**Wildwood Park Welcome Center ITB  
Addendum No. 02**

<b>Project Name: Wildwood Park Welcome Center</b>	<b>Project No.:</b> RFP#21-22-54
<b>Prepared By: Mark Nottingham</b>	<b>Date:</b> 6-30-2022

TEC PROJECT NO. 2022005  
 CLIENT PROJECT NO. ---  
 PROJECT TITLE  
**WILDWOOD PARK WELCOME CENTER & PLAYGROUND SITE**  
 DRAWING TITLE  
**UTILITY DETAILS - WATER**

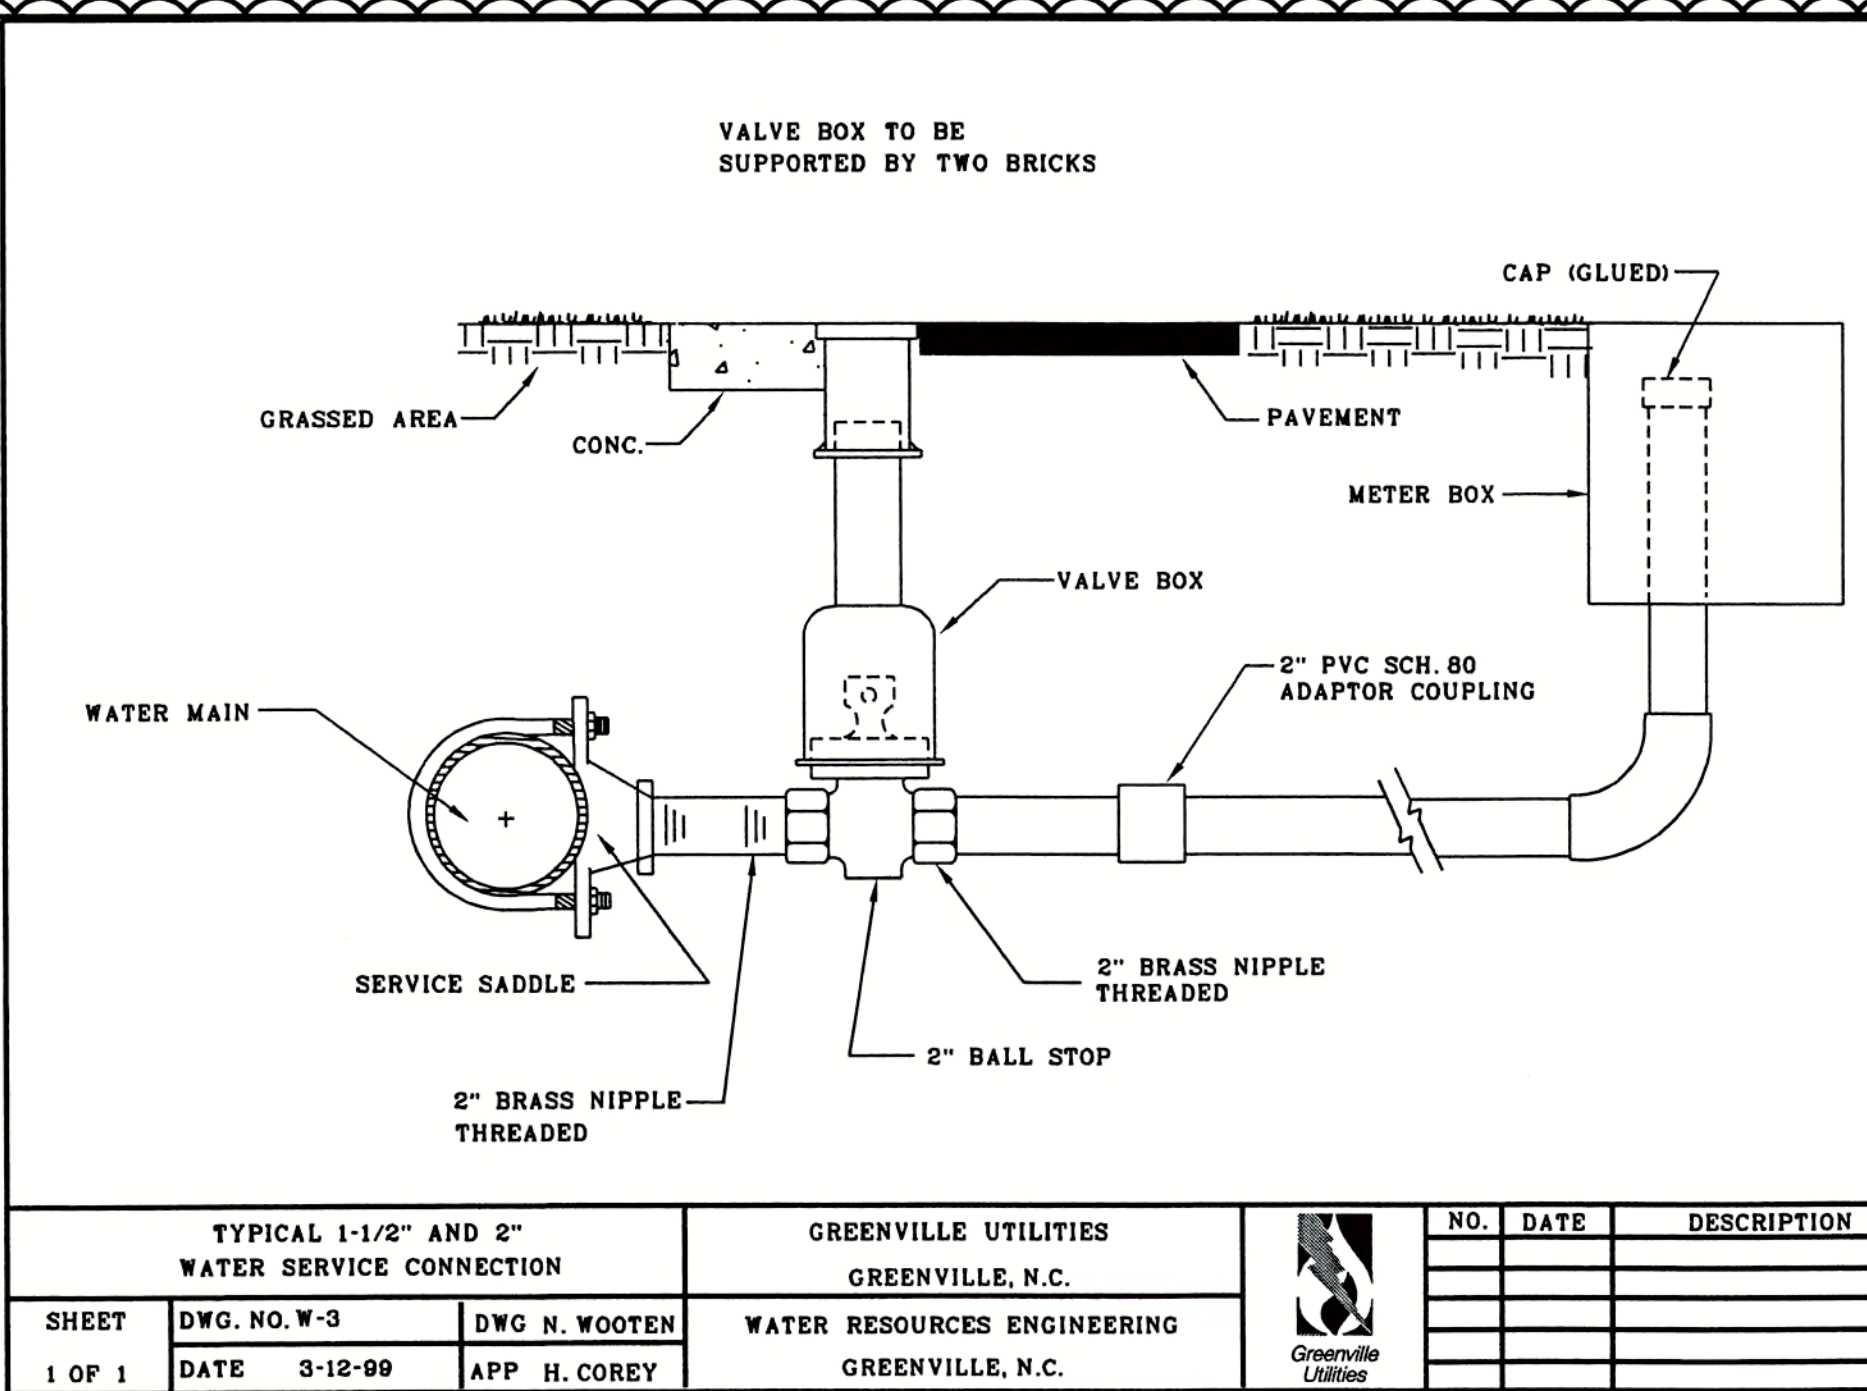
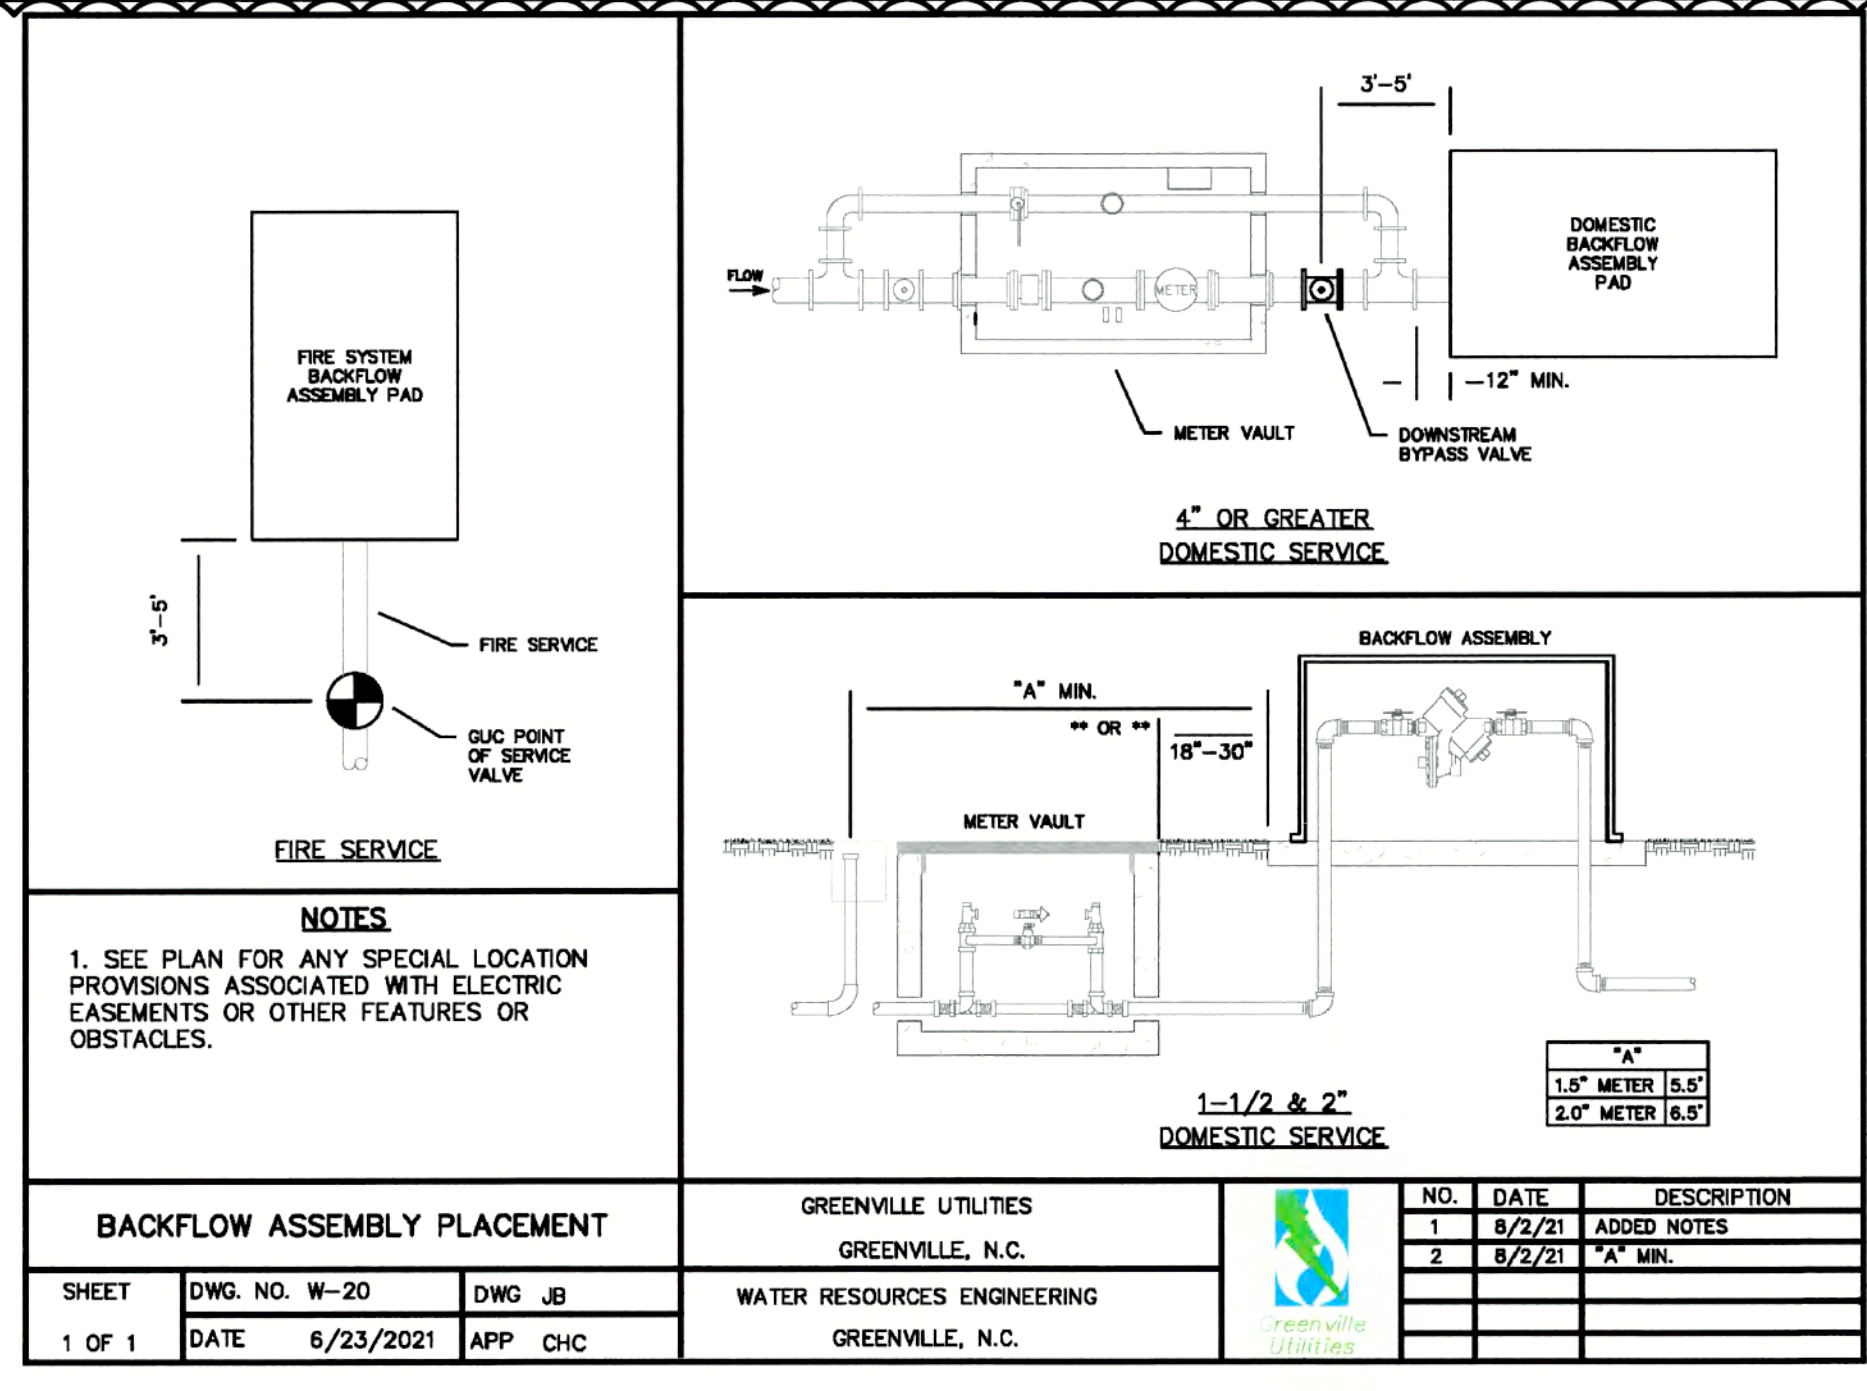
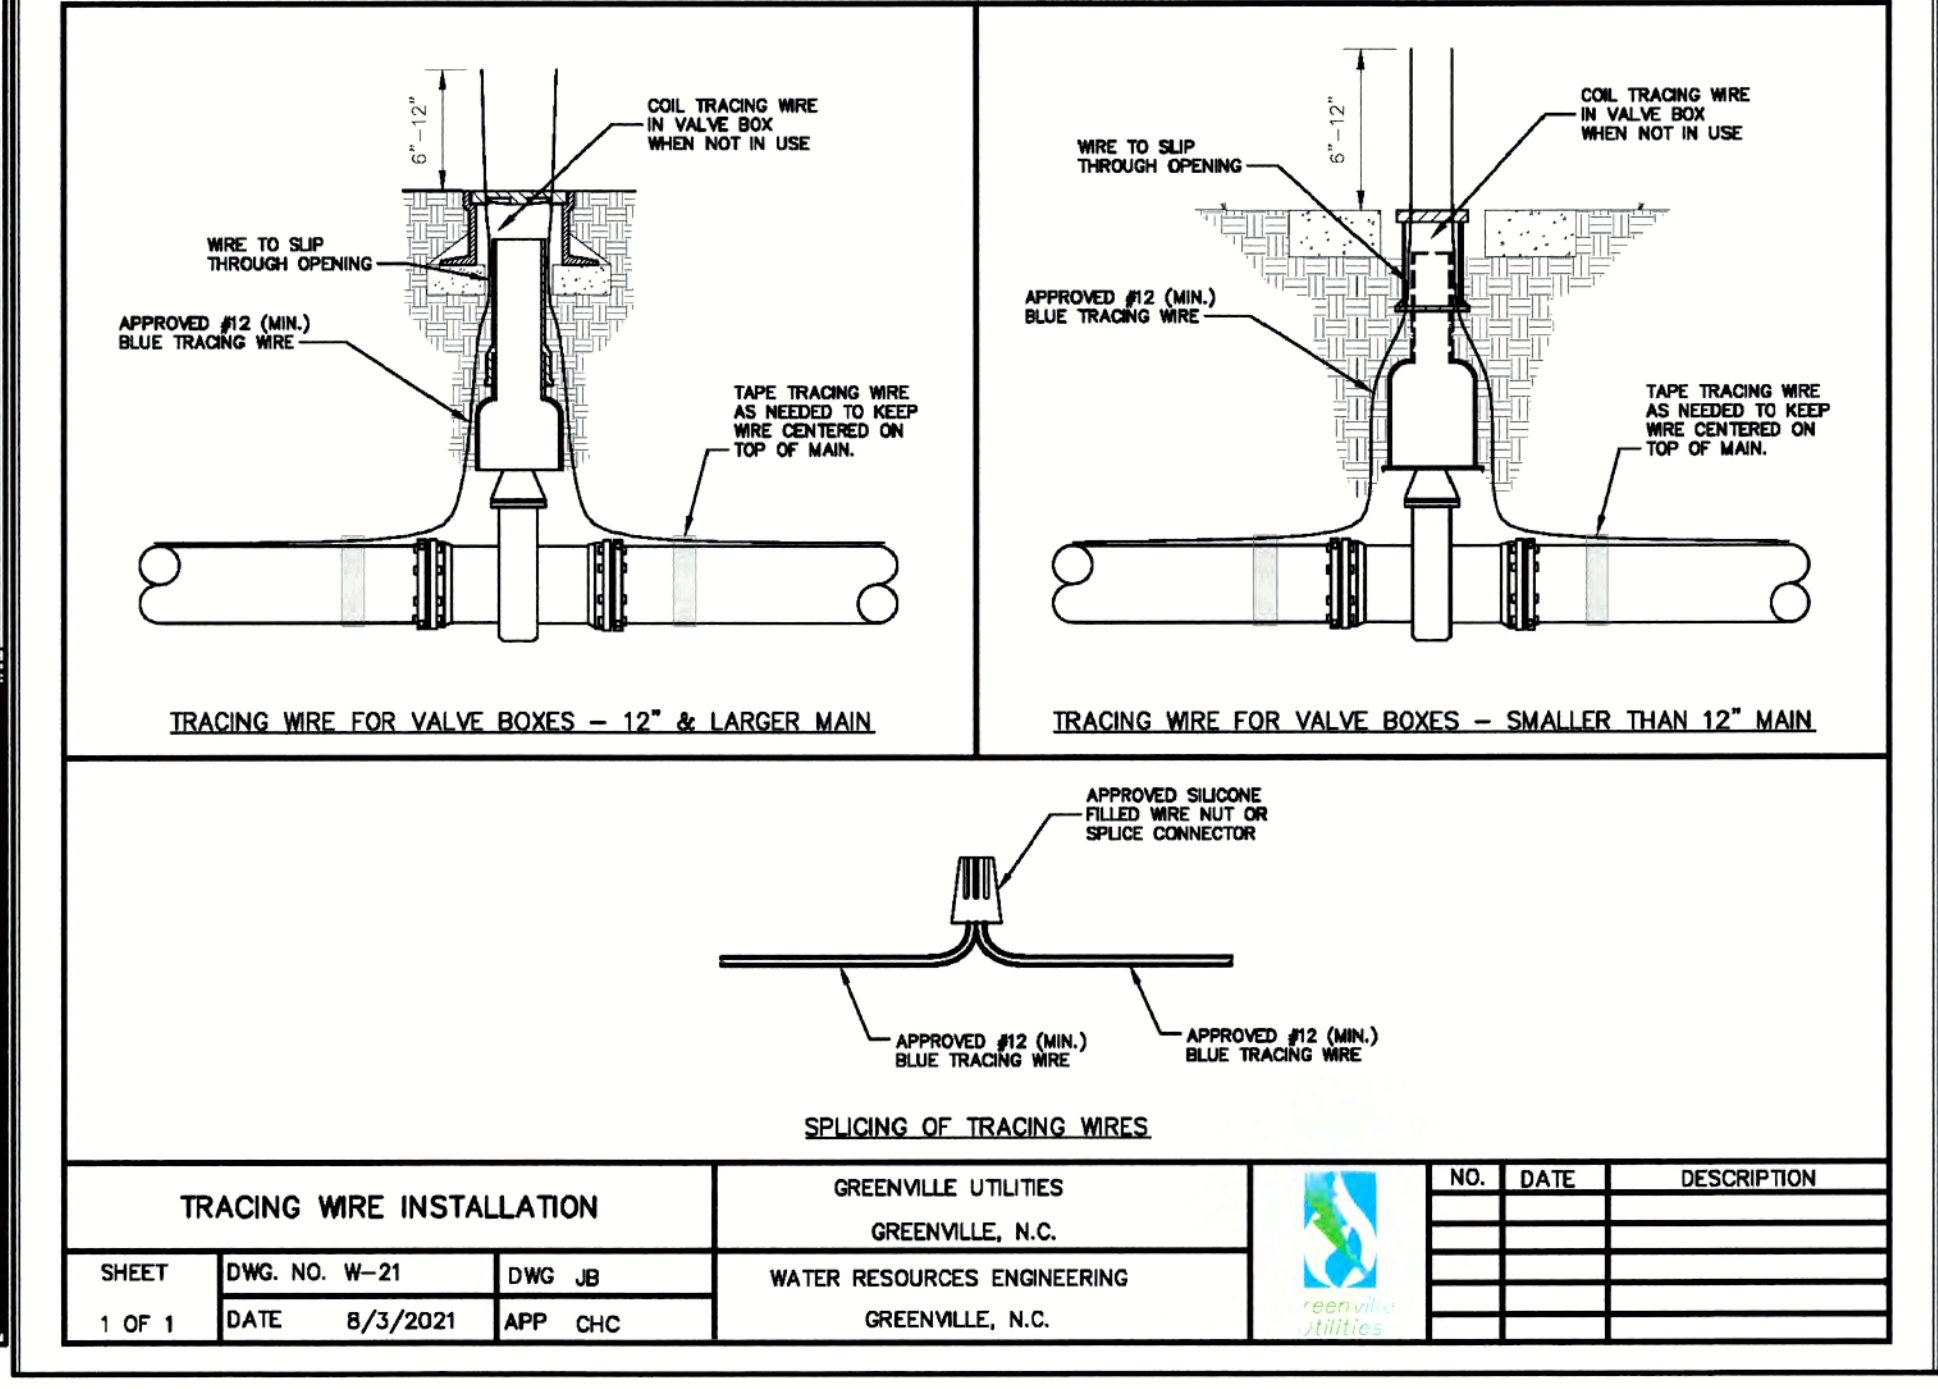
- Review comments have dictated changes to four of the plan sheets (L0.1, C3.1, C3.2, C4.1) Revised sheets are attached.
